**Product Family: Ariens 920014 Sno-Thro Models with Briggs & Stratton Engines**

**Subject: Inspect and Repair Units Before Sale**

## **BRIGGS & STRATTON SERVICE NOTIFICATION**

**SUBJECT:** **IMPORTANT NOTICE – CARBURETOR BOWL NUT**

Figure 1

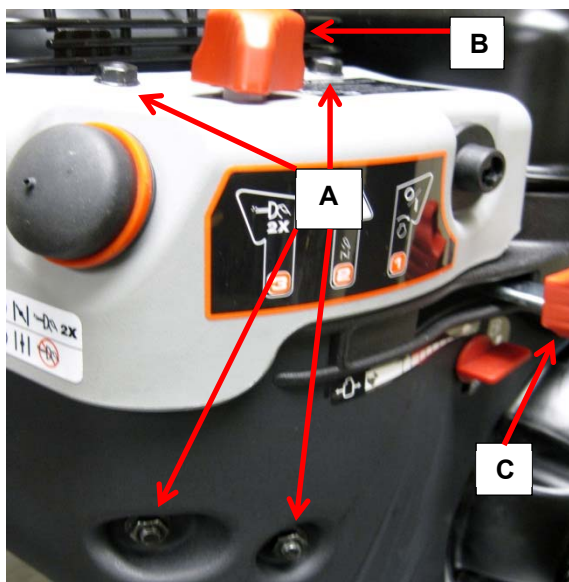
- 1) Remove upper and lower shroud bolts (**A**, Figure 1) using a 10 mm socket.
- 2) Remove choke shaft (**B**) by applying uniform upward pull force. The upper shroud can then be gently lifted upward and set to the side, leaving the primer hose and ignition wires attached.

- 3) Pull off throttle control knob (**C**) with uniform outward force.
- 4) Then, with the fuel shut-off valve in the off position, carefully remove the lower shroud and set aside. The cover over the throttle control is not removed but needs to be pulled outward to assist in the removal of the lower shroud.

Figure 2

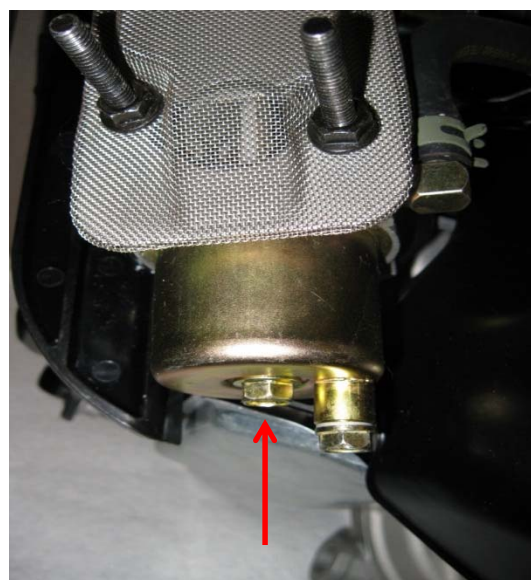
- 5) Using a ¼ inch drive 10 mm socket, loosen the bowl nut (arrow, Figure 2) approximately 1 turn.
- 6) Attempt to continue loosening the bowl nut by hand approximately 2 more turns. The nut should turn freely. Do not completely remove the bowl nut.

- a. If you CANNOT loosen the bowl nut freely by hand, STOP. This carburetor must be replaced. Order and install replacement carburetor P/N 591154. Proceed to step 7.

- b. If you CAN loosen the bowl nut freely by hand, this carburetor is OK and you may re-tighten the bowl nut to 75 lb-ins. Proceed to step 7.
- 7) Using a permanent black marker, place a black mark after the engine identification stamping on the base of the engine (starter motor side).
